II. REMARKS

Objections to the Drawings

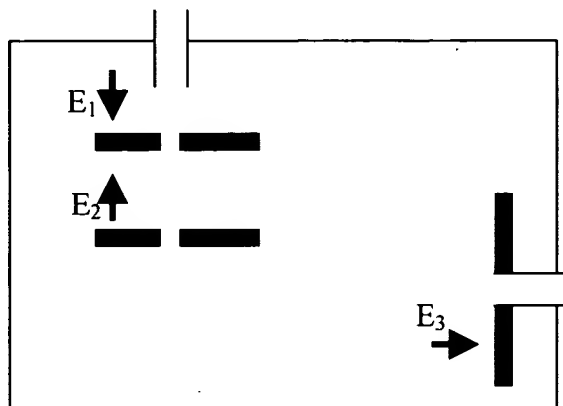
ionization chamber having, *inter alia*, three electric fields and means for generating a gaseous stream in a gas flow path extending from a first electrode to a second electrode. Solely for the Examiner's convenience and without any intention to limit the invention, an exemplary arrangement of electric fields is illustrated in the following figure (adapted from Fig. 2 of the instant application).

FIG. 1
(PRIOR ART)

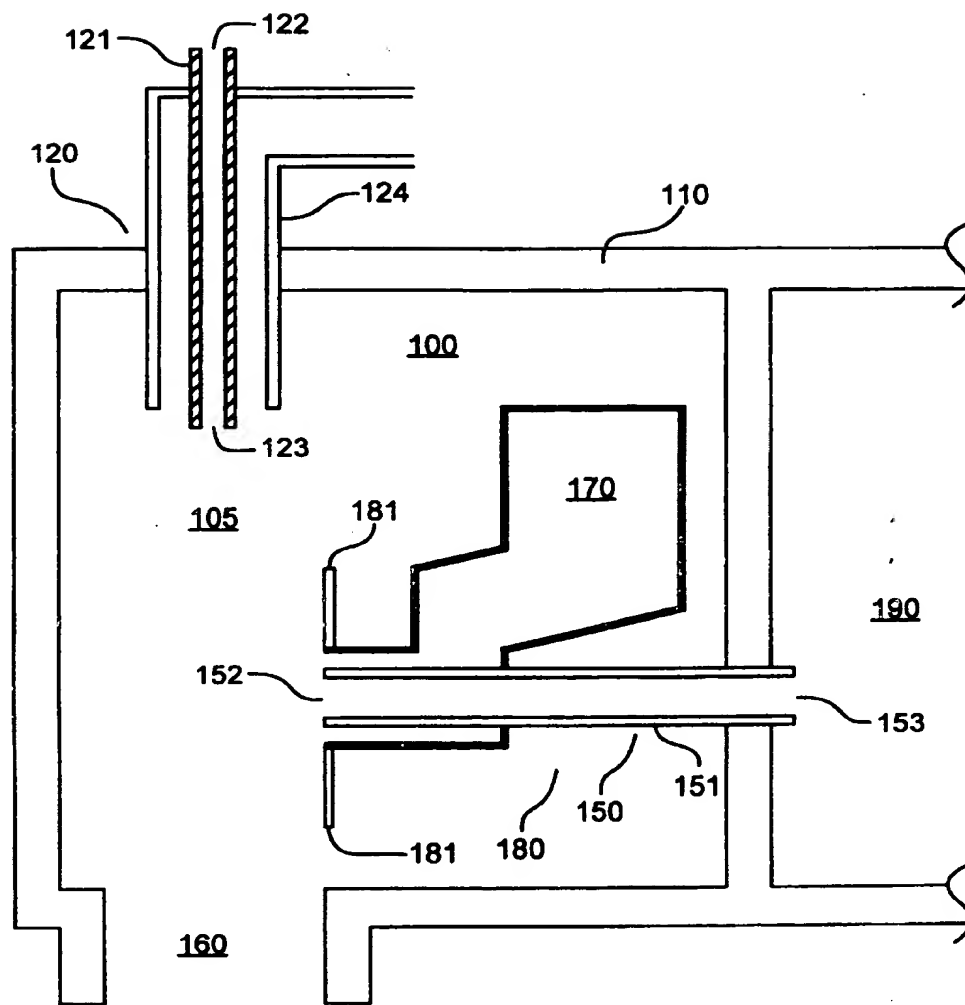
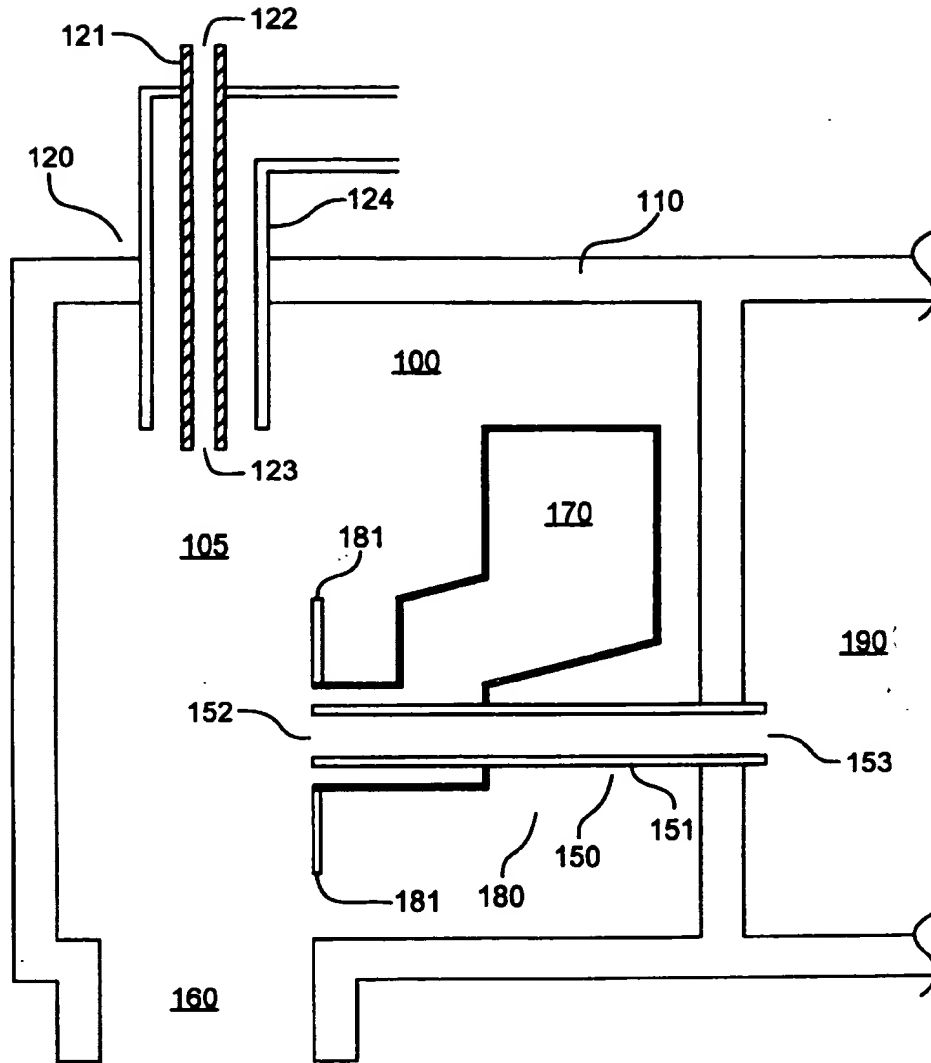
Figure 1 was objected to as being incorrectly labeled. Applicants have amended the legend of Figure 1 to include the words "Prior-Art". This objection is believed to have been addressed by this amendment, and Applicants respectfully request withdrawal of this objection.

Figure 1 is amended to comply with MPEP § 608.02(g), indicating that the subject matter of Figure 1 is prior art.

FIG. 2

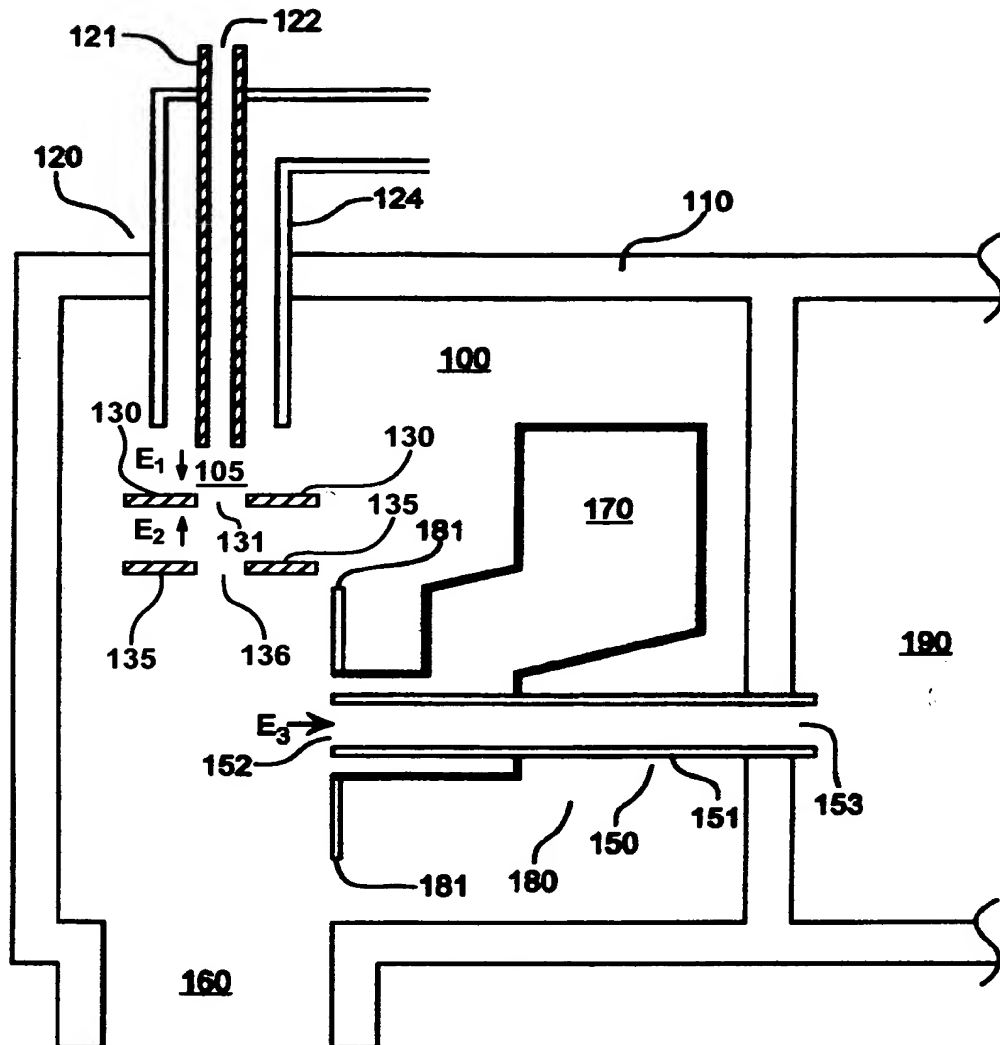
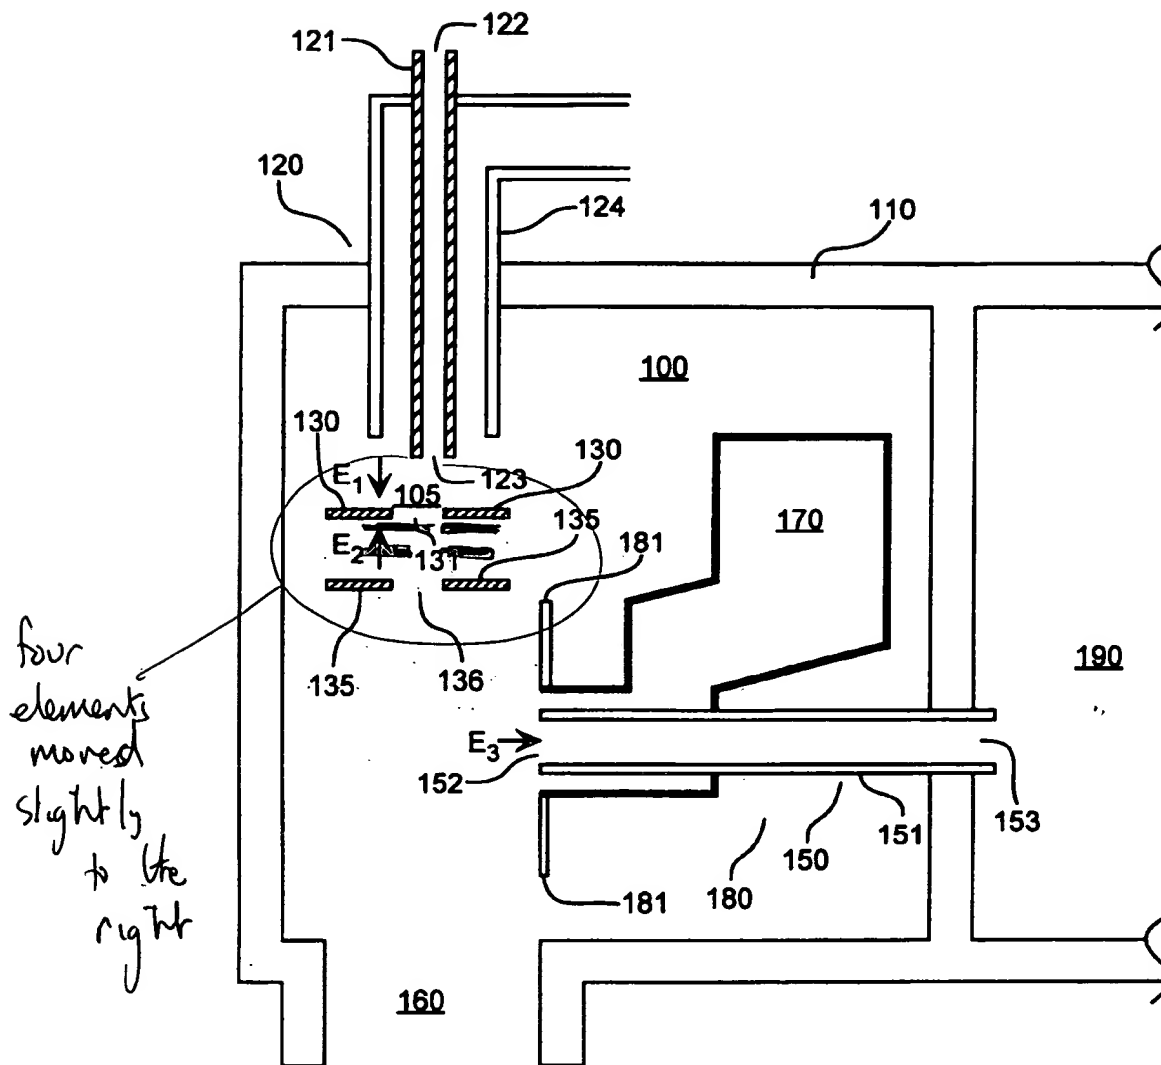
The drawings were objected to as failing to comply with 37 CFR § 1.84(p)(5), assertedly because a) the written description of the drawing recites the reference sign “154”, which is not shown in a drawing, and b) because the drawings show a reference sign “153” which is not described in the written description.

The specification is amended in one place in order to allow the figures to comply with 37 CFR § 1.84(p)(5). The reference sign "154" in the written description has been amended to "181".

The specification has been amended to provide a description of element “154”.

Applicants respectfully submit that description of reference sign “153” may be found in line 25 on page 9 of the specification.
